PRELIMINARY PLANS NOT APPROVED FOR CONSTRUCTION

CITY OF INGLEWOOD, CALIFORNIA PUBLIC WORKS DEPARTMENT
TRAFFIC SIGNAL IMPROVEMENT PLANS HOLLYWOOD PARK PROJECT PRAIRIE AVENUE FROM ARBOR VITAE STREET TO PINCAJ DRIVE
PERMIT NUMBER: PLAN SCALE: AS NOTED SHEET NO. 02 OF 4 PLAN NO. SS-XXXX

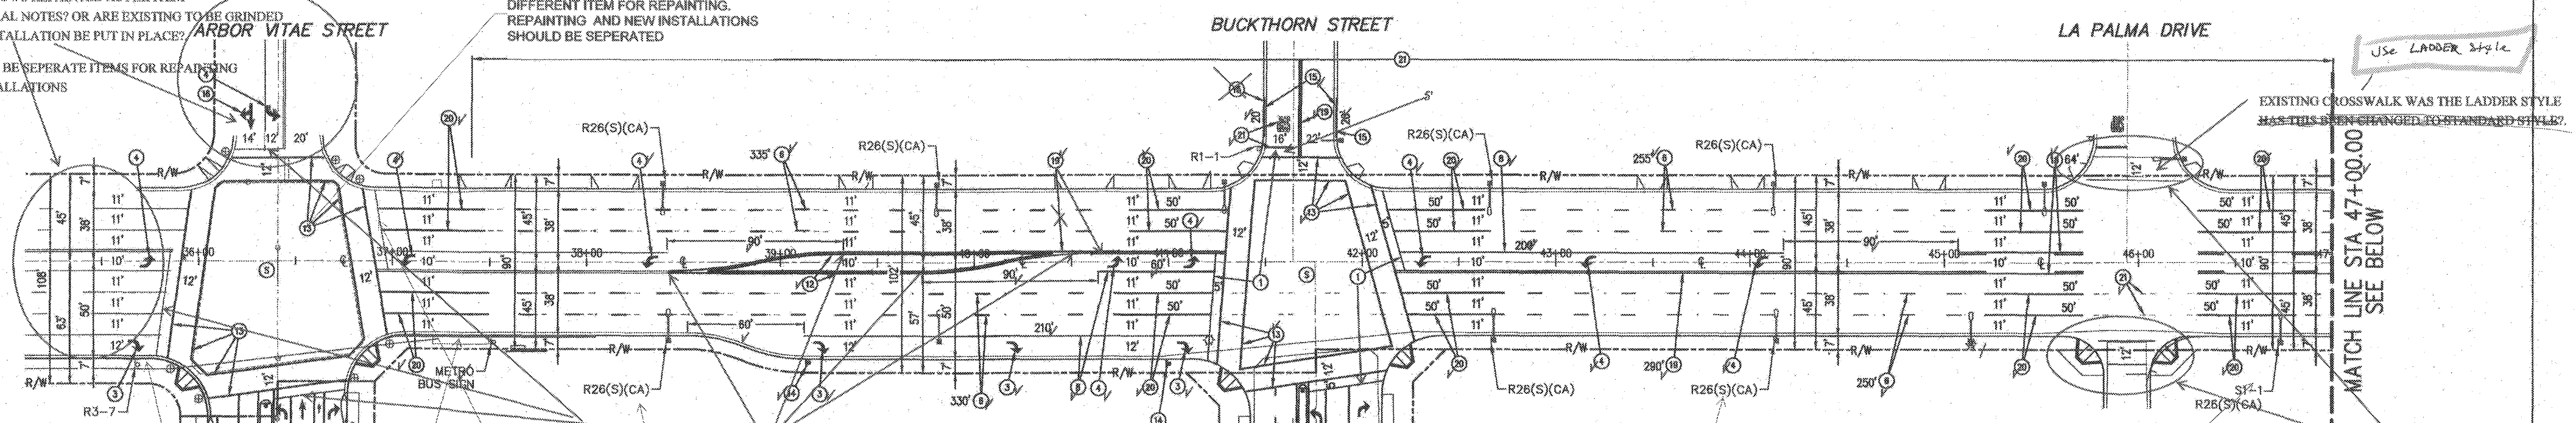
ACCORDING TO ITEM 6 OF THE GENERAL NOTES, ALL EXISTING STRIPING TO REMAIN SHALL BE REPAINTED

ARE THESE ARROWS REPAINTED AS PER ITEM 6 OF THE GENERAL NOTES? OR ARE EXISTING TO BE GRINDED AND A NEW INSTALLATION BE PUT IN PLACE?

THERE SHOULD BE SEPERATE ITEMS FOR REPAINTING AND NEW INSTALLATIONS

NOTE 13 IS NOT CORRECTLY DESCRIBED. ALSO, IF REFURBISHED, CREATE A DIFFERENT ITEM FOR REPAINTING AND NEW INSTALLATIONS SHOULD BE SEPERATED

SHOW EXISTING FIRE HYDRANTS ON PLAN (TYP.) ALSO SHOW BLUE MARKERS LOCATIONS - THESE ITEMS SHOULD SHOW ON STRIPING PLANS

LIMIT LINES SHOULD ALSO BE REINSTALLED/ REFURBISHED SIMILAR TO CROSSWALKS.

MARK BEGINNING AND END OF DETAIL 29 AND SHOW LENGTH (TYP.)

SHOW SPEED LIMIT (SPEED LIMIT WAS ASSUMED TO BE 40 MPH OR LESS FOR PLAN CHECK) Speed Limit on Prairie = 40

SHOW NEW STOP SIGNS, STOP BARS AND PAVEMENT LEGENDS IF THEY ARE INCLUDED WITH THE ON-SITE PLANS, THEN INDICATE SO

S1-1 DOES NOT EXIST. INSTALL HERE ASSEMBLY C (SPEED LIMIT 25 MPH WHEN CHILDREN ARE PRESENT)

AND/OR LIMIT LINE (TYP.)

ADD PROPOSED SIGNS

Handwritten note: "Prairie striping shall Match Prairie Ave Improvement Plans. City will provide copies, so you can Match."

THESE DISTANCES SHOULD BE IDENTIFIED 5' MIN SHOULD BE PROVIDED SINCE RAMPS DO NOT ALLIGN CORRECTLY WITH CROSSWALK (TYP.)

WHITE LIMIT LINE SHOULD BE INSTALLED AT ALL FOUR APPROACHES. PAVEMENT ARROWS LOCATIONS TO BE ADJUSTED ACCORDINGLY

DRAW LADDER CROSSWALKS TO THE CORRECT SCALE AFTER THE CROSSWALK DETAILS ARE DETERMINED.

SHOW CROSSWALK DETAILS ON PLAN. STANDARD PLANS GIVES ONLY GUIDANCE - REFER TO SHEET 22 OF THE 2018 STANDARD PLAND A24F FOR LADDER CROSSWALK. AFTER DETAILS ARE ESTABLISHED AND DRAWN BELOW HERE, THEN ADJUST CROSSWALKS AT INTERSECTIONS ACCORDINGLY USING THE NEW ESTABLISHED DETAILS

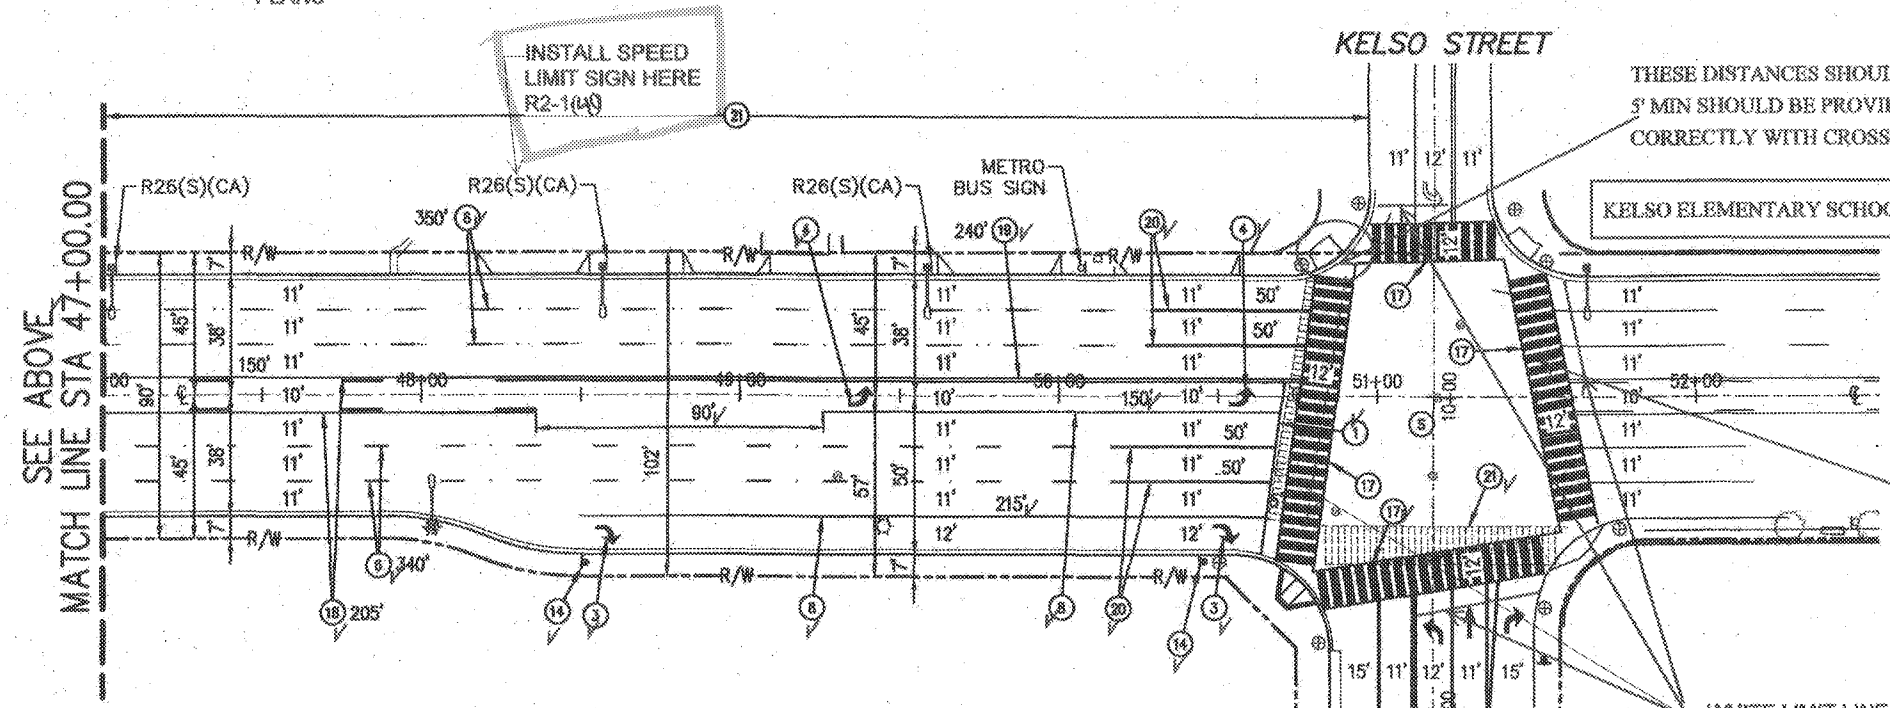
Handwritten note: "Add picture" with a box containing "Right Lane Must Turn Right" and "R3-7".
